LAS CAMAS SOLAR PROJECT

FINAL SUBSEQUENT ENVIRONMENTAL IMPACT REPORT

State Clearinghouse # 2021080196

November 2024

Figure 2-1: PV Panel Reflection Angle Illustration. Reflectance depends on incidence angle between panel normal (i.e. facing) and sun position. Large incidence angle yields more reflected sunlight (ForgeSolar. 2024).

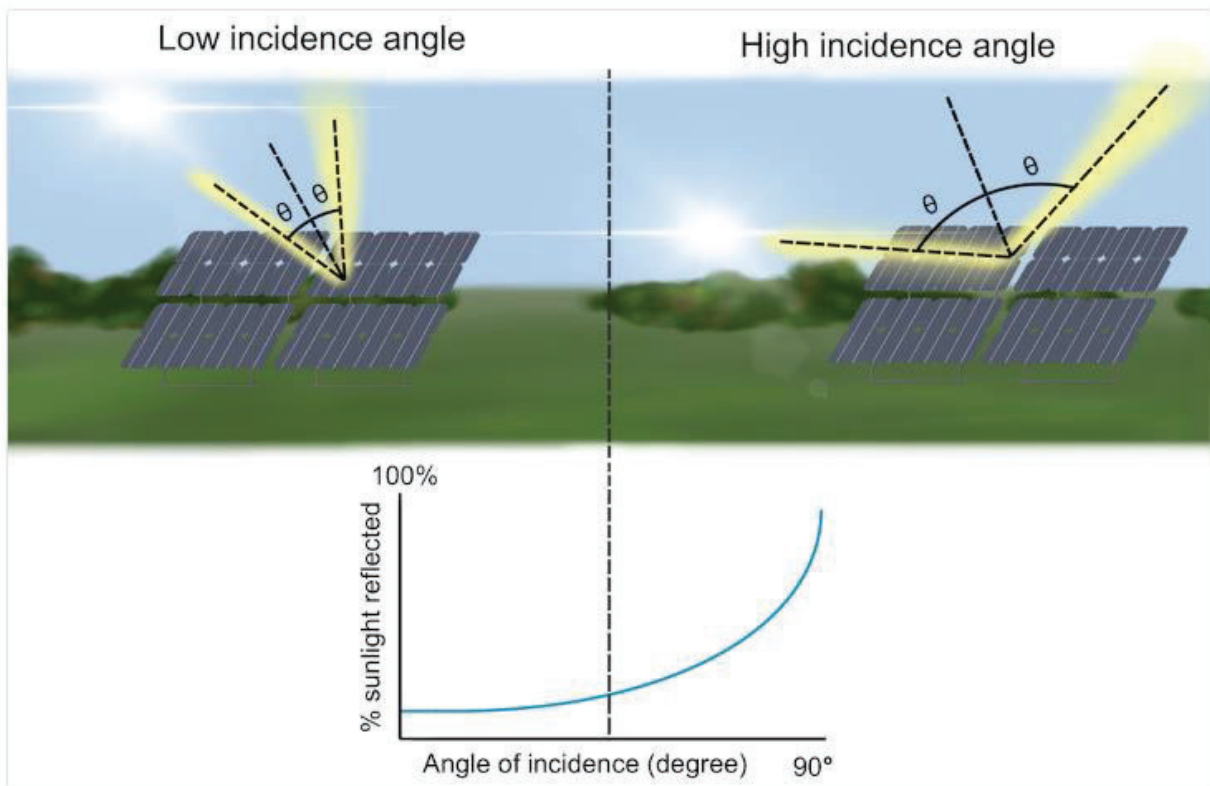
The commenter expresses concern over having what he terms mirrors pointing toward his property and the destruction of views due to the topography and implementation of the project. APNs 078-190-010 and 078-190-009 border the solar project site on the south.

As described in Section 3.1, *Aesthetics*, and shown in Figures 3.1-3 through 3.1-4, the project would not use mirrors, but instead would use darkly colored photovoltaic panels that would tilt and be oriented to face east-west. Therefore, the panels would not be directly angled toward the commenter's property, which is located south of the solar project site in a relatively flat area. As described under Impact AES-4, which has been revised for better clarity in Chapter 3, *Draft SEIR Errata*, "...When the sun is high in the sky (close to noon or in the summer) and the panel is low to the ground, any reflection would be upward toward the light source and back into the atmosphere away from terrestrial-based receptors. When the sun is low on the horizon (near dawn or dusk or in the winter), the sun's angle in the sky is low; reflected rays would still be directed away from terrestrial-based receptors because the maximum downward angle of the arrays would not be below 30 degrees." Figure 2-1, below, is a graphic that helps illustrate the concepts of what a reflection angle looks like when the sun is high in the sky or low on the horizon.

There is also a 237-foot distance from the southern edge of where the panels would begin on the solar site, as shown in Draft SEIR Figure 2-2, and the commenter's property boundary. Therefore, due to panel orientation and the offset for where the panels begin, the surfaces of the solar panels would not point towards the commenter's property, even with the topography of the site. In addition, Impact AES-3 evaluated operational impacts under *Changes in Proposed Land Uses and Development from the Community Plan* starting on page 3.1-32 and under *Additional Proposed Development Outside of the Community Plan* starting on page 3.1-35 of the Draft SEIR, which evaluated the light and glare impacts. This analysis identified that the panels would be darkly colored, to absorb sunlight, and would receive an anti-reflective coating. The panels would not have the appearance of mirrors. The Draft SEIR found that no new or substantially more severe significant impacts would result beyond those identified in the previous EIR and no additional mitigation would be required.
